Amendment No. 4 28th September 2016

AIS-008 (Revision-1)

“Installation Requirements of Lighting and Light - Signalling Devices for Motor Vehicle having more than Three Wheels including Quadricycles, Trailer and Semi-Trailer excluding Agricultural Tractor”

Figure 6

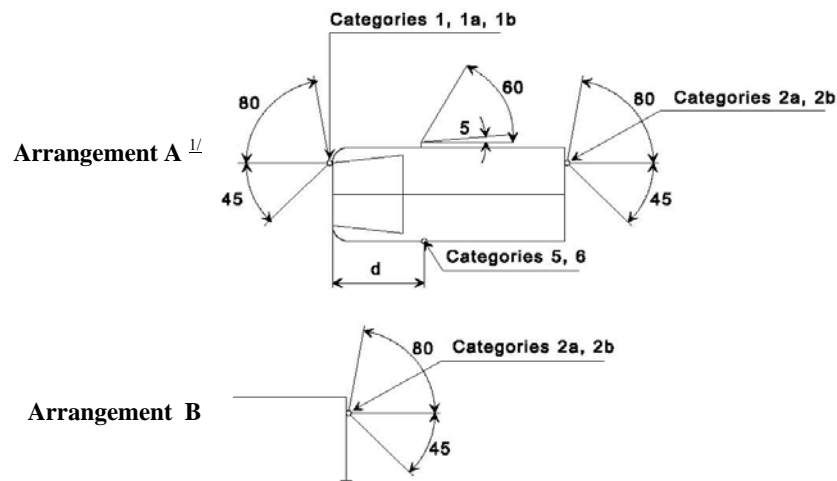
8. Page No. 24/66, clause 6.5.3, Arrangements (Ref.Fig.6), First line

Substitute “---- L7, M and N:” for “----M and N:”

clause 6.5.3, twenty-fifth line

Substitute “for all L7and M1vehicles;” for “for all M1vehicles;”

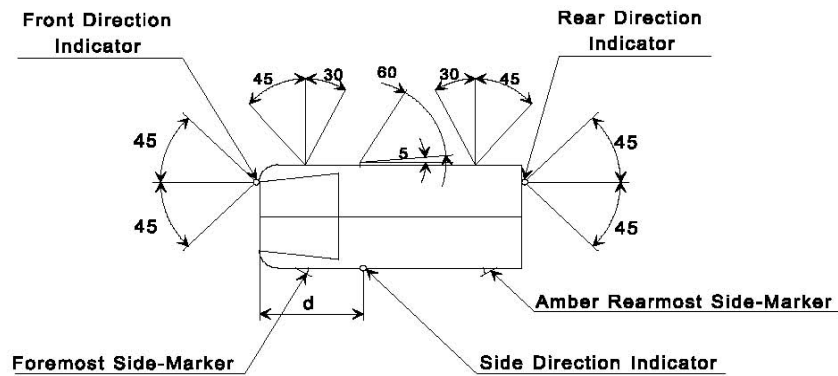
10. Page No. 26/66, clause 6.5.5.2.

Substitute following text for existing text:

11. Page No. 26/66, footnote.

Substitute following text for existing text:

“6.5.5.2. or, at the discretion of the manufacturer, for L7, M1 and N1 category vehicles ^{2/}.”

Note: 1/ The value of 5° given for dead angle of visibility to the rear of the side direction-indicator is an upper limit. $d \leq 1.80$ m (for L7, M1 and N1 category vehicles $d \leq 2.50$ m).

2/ The value of 5° given for the dead angle of visibility to the rear of the side direction-indicator is an upper limit $d \leq 2.50$ m.
